Addendum to the  
Environmental Impact  
Assessment Report

**NISA**  
*North Irish Sea Array*

# Chapter 5

## Consideration of Alternatives

**Image A5.1 Site Refinement Process**

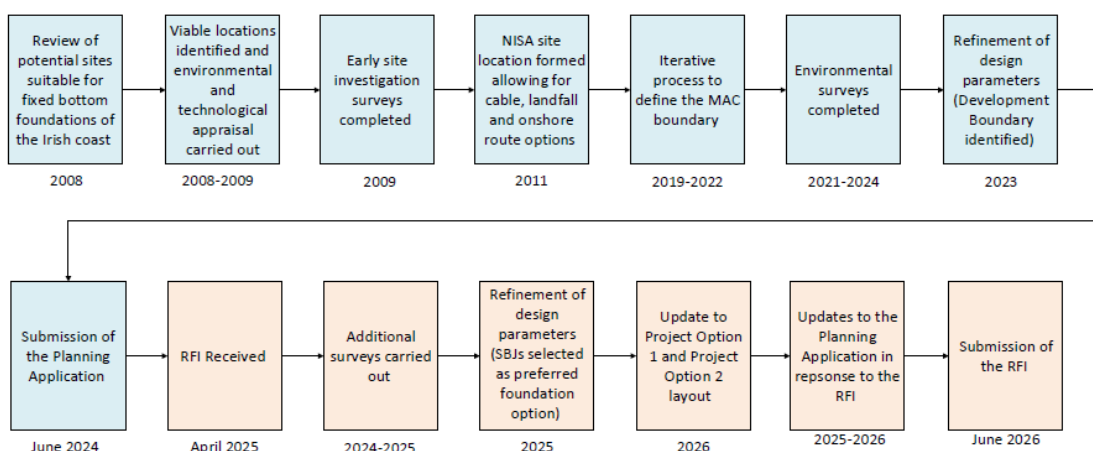
**The only change required to Section 5.5.4 in Chapter 5 of the 2024 EIAR is an update to Image 5.1: Site Refinement Process to incorporate the post-submission refinement stages of the planning application.**

**For the purpose of clarity, Image 5.1 from Chapter 5 of the 2024 EIAR shall be deleted and replaced with Image A5.1 below.**

**Image A5.2 Offshore Development Area and associated constraints**

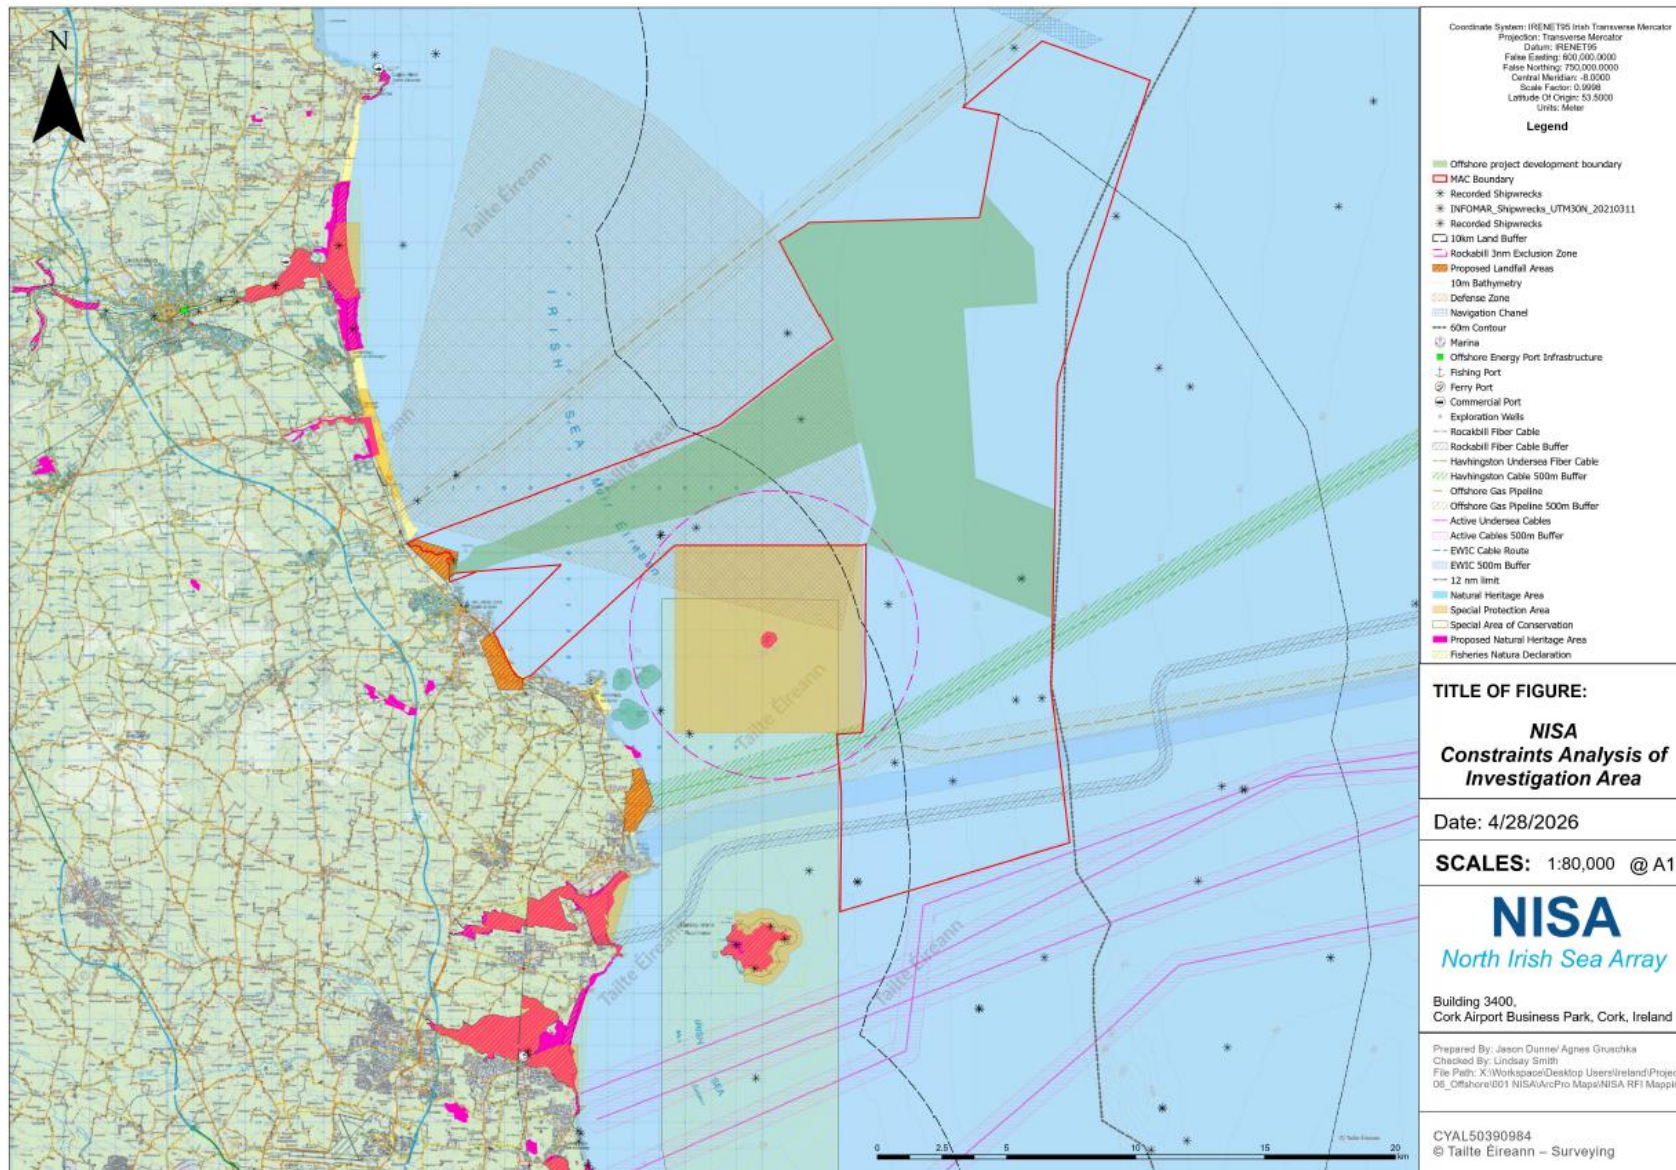
**The only change required to Section 5.6.1.1 in Chapter 5 of the 2024 EIAR is an update to Image 5.8 to improve the legibility of the figure. This update includes a change to the name “Infrastructure Boundary” to “Offshore Project Development Boundary” and some additional information including ‘Proposed Natural Heritage Areas’ and ‘Proposed Landfall Area’.**

**For the purpose of clarity, Image 5.8 from Chapter 5 of the 2024 EIAR shall be deleted and replaced with Image A5.2**
